Access Compliance Report

Public Rights-of-Way

(Pedestrian Signals)

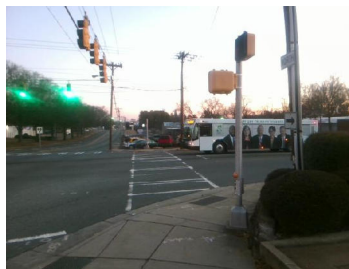
PROW/ADA: TMUTCD 4e.08, R404.3, R404.2, R406.2

Possible Solutions: Replace Signal Push Button With APS Button on New Post. Remove & Relocate Sign.
